Agenda Item #5

Application 2026-18-CA

920 Conti Street

After-the-fact replacement of existing wood front entry door with new wood entry door

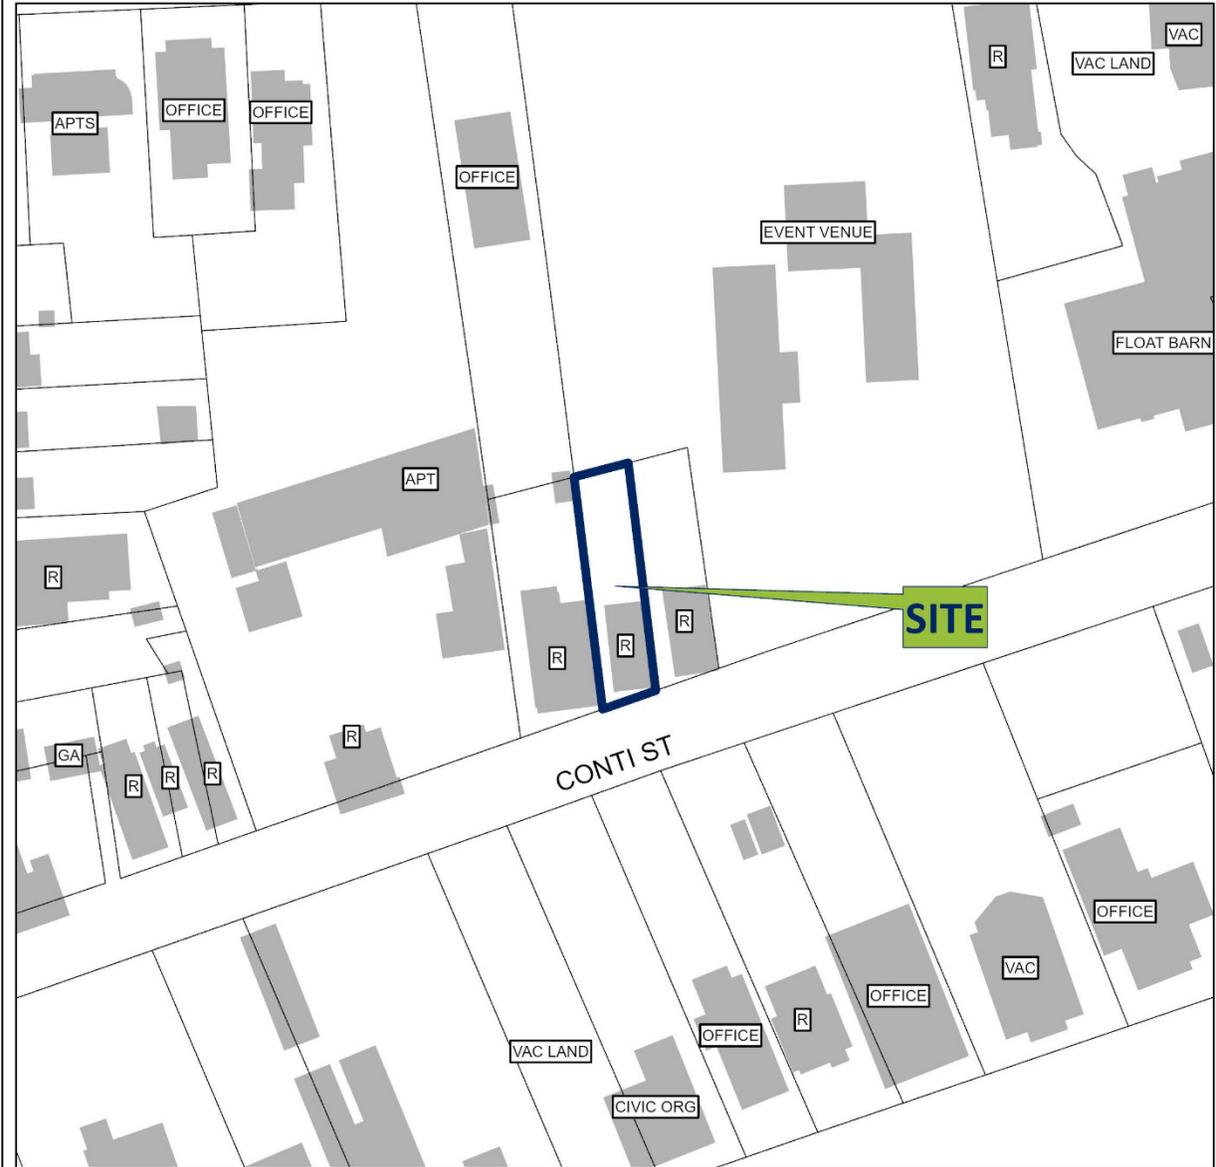
The historic paneled wood door with three lights over three horizontal panels was highly typical of the period from 1900 to 1910. Unless there is photographic evidence of a different front door at this property, it is appropriate to assume that the door was original to the property. According to the *Design Guidelines*, replacement of an original door is inappropriate unless the door has deteriorated beyond the point of repair. It is difficult to ascertain from available photos if the door had or had not deteriorated to this point.

If an original door has deteriorated to the point that repair is impossible, the *Guidelines* require that a replacement door reflect the age and style of the subject property. Paneled wood doors with glass lights were common in the period between 1900 and 1910. However, the specific configuration of the replacement door – a two-over-two light above a single rectangular panel – would have been atypical when the house was constructed in 1903. At that time, the most common lighted door configurations featured one large light or two paired lights over a variety of wood panel configurations. Doors with two-over-two lights set above two or three wood panels were commercially available, but they are rarely depicted as front entry doors in the house design books of the period. This door type was uncommon and primarily used for accessory structures, such as ice houses. Staff were able to find one house design catalogue from 1900 that shows a front entry door with a two-over-two light. Instead of a single wood panel, the light is set above three horizontal panels, similar to the configuration of the door removed from the subject property.

The head height of the existing opening has been lowered to accommodate the replacement door, which is shorter than the door that was removed. In discussions with staff, the property owner stated that the existing opening was so out of plumb that it would not be possible to install a new door that was both plumb and large enough to fit the opening. To fit the new smaller door within the opening, the owner installed a flat trim board over the decorative carved lintel. This brought down the head height without requiring removal of the original lintel. In other words, the decorative lintel remains *in situ* and could be restored at a later date.
